**STAFF REPORT**  
**COMMUNITY DEVELOPMENT DEPARTMENT**

HEARING DATE: 3/23/2021  
 TO: Mayor & City Council  
 FROM: Joe Dodson, Associate Planner  
 208-884-5533  
 SUBJECT: H-2020-0124  
 Ambles Run Subdivision  
 LOCATION: The site is located on Lot 26, Block 1 of the county Dunwoody Subdivision, approximately ¼ mile east of N. Locust Grove Road and a ½ mile south of Chinden Boulevard, in the SW ¼ of the NW ¼ of Section 29, Township 4N., Range 1E.

Annexation & Zoning of 2.88 acres of land with an R-2 zoning district and a preliminary plat consisting of 6 single-family residential lots, by HomeFound Group.

B. Preliminary Plat (dated: 12/17/2020) NOT APPROVED

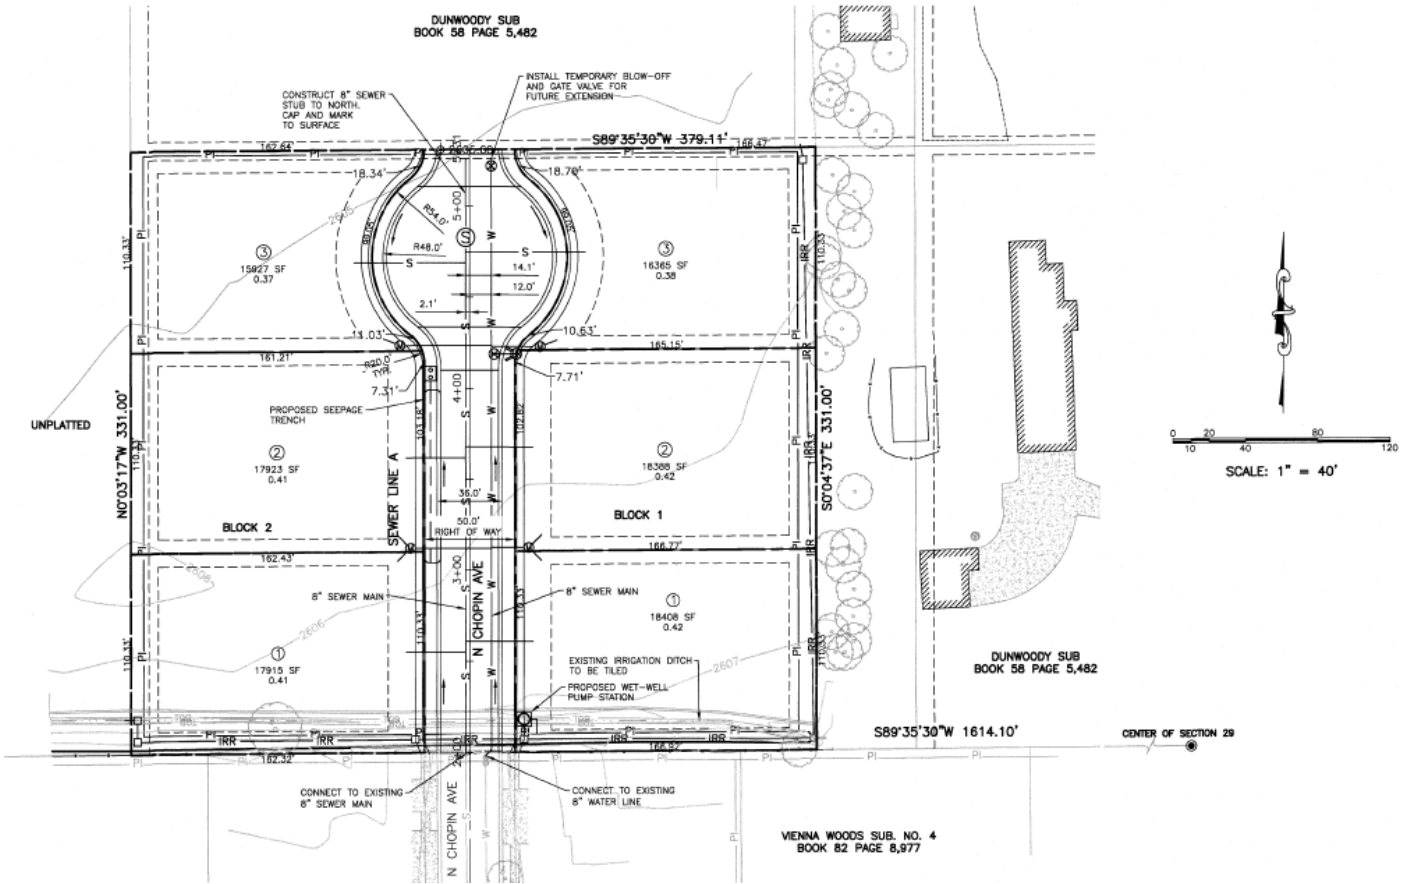
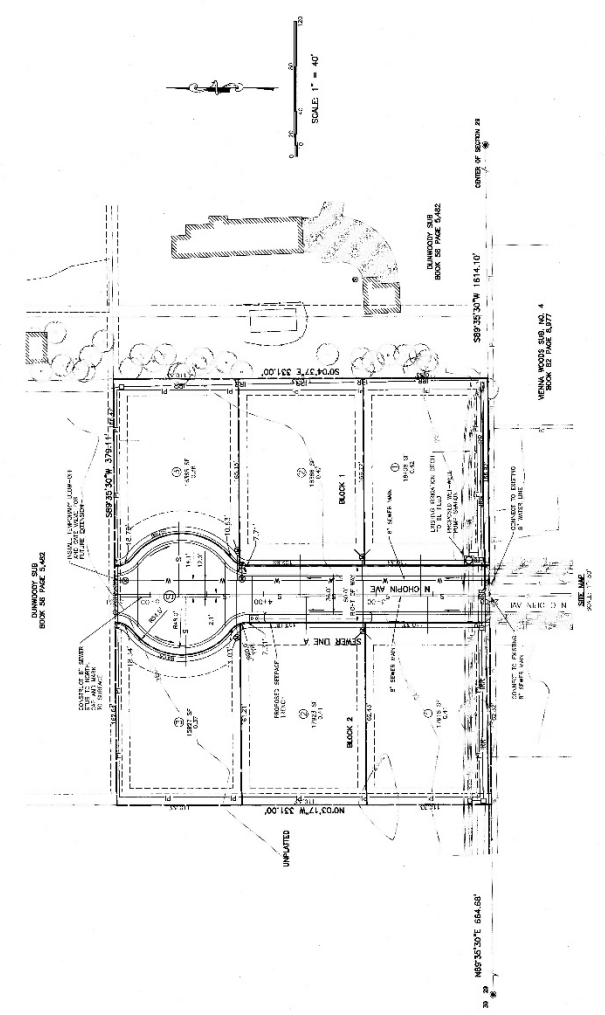
*The proposed layout is sufficient for the proposed 6-lot subdivision but Staff believes it does not adequately set the stage for future development to its north and west. Therefore, Staff is recommending the Applicant revise the plans to show a stub street to the west as discussed to meet more of the comprehensive plan objectives and policies. There are multiple placements of the stub street that would provide for better future circulation than only providing a stub to the north. However, Staff finds it appropriate to recommend a location that minimizes the amount of wasted pavement should Chopin Avenue ever get extended further in the future.*

*Staff recommends placing the western stub street along the northern property boundary as a full street section per ACHD requirements. However, the Applicant should work with ACHD on a reduced street section for this stub street to minimize the impact to this property. At a maximum, with 5-foot attached sidewalks and a 33-foot street section, the western lots would be required to be reduced by 47 feet to incorporate the required right-of-way. ACHD has reduced street sections if no on-street parking is desired which would reduce this area even further. With the maximum amount of right-of-way taken, the proposed lots would still exceed the minimum dimensional standards of the requested R-2 zoning district.*

*As discussed previously, the proposed 4-foot wide sidewalks do not meet ACHD standards and should be widened to 5 feet wide. The Applicant is aware of this but has not yet provided updated plans. Regardless, the sidewalks in this development will continue connections through the project from the Vienna Woods Subdivision to the south. These connections will allow future residents easy access to the nearby sports complex to the southeast.*

*Staff is recommending the proposed parkways be widened to 10' to increase the amount of open space for the small development even though there is not a requirement to meet any minimum open space standard. As discussed within the Comprehensive Plan analysis section earlier, increasing the width of the parkways allows the project to provide at least 5% open space which helps meet the intent of the code and comply with the comprehensive plan. In addition, the wider parkway would allow for healthier trees and provide the Applicant the opportunity to use a wider range of trees within the parkways, including larger Class III trees if so desired. Staff recommends constructing the recommended western stub street with 8-foot parkway on its southern side to match what is currently proposed. This parkway should also be landscaped in accord with UDC standards.*

- b. Revise the plat to show 10-foot wide parkways with 5-foot wide detached sidewalks consistent with UDC 11-3A-17 and Staff's recommended changes.
- 3. The landscape plan included in Section VII.D, dated November 18, 2020, shall be revised as follows at least ten (10) days prior to the City Council hearing:

## D. Conceptual Building Elevation

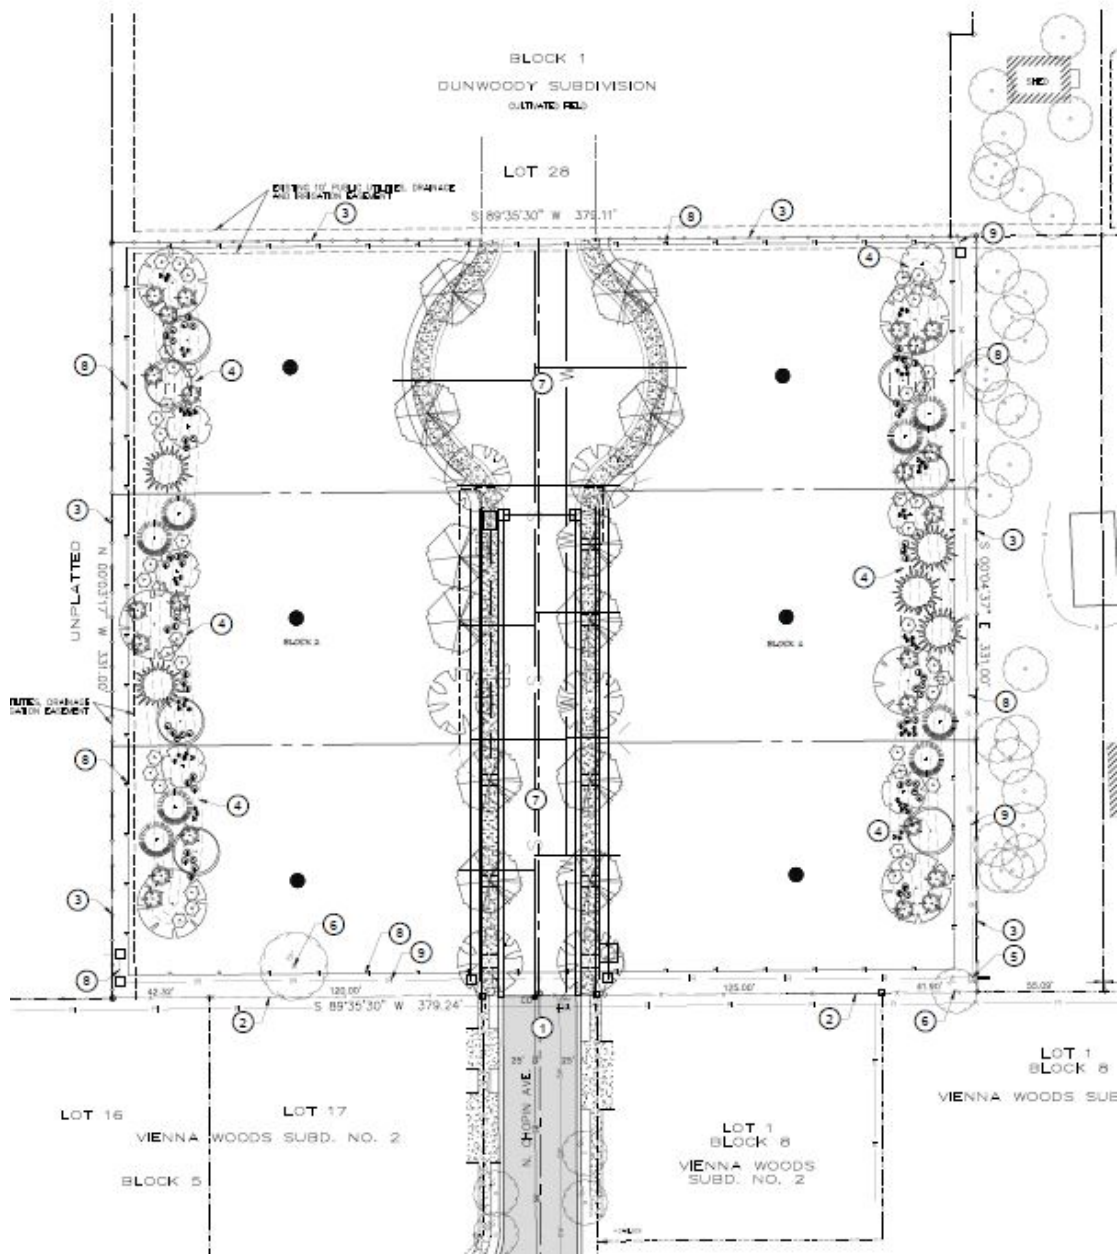
The Applicant did not submit conceptual building elevations other than the one elevation submitted with the Narrative. That elevation is an example of what the expected home builder constructs. Detached single-family homes do not require design review approval prior to building permit submittal and therefore Staff does not review these for compliance with any standards. However, the submitted elevation does depict larger homes commensurate with estate lots and shows varying rooflines with different building and accent materials that come together and show high-quality construction.
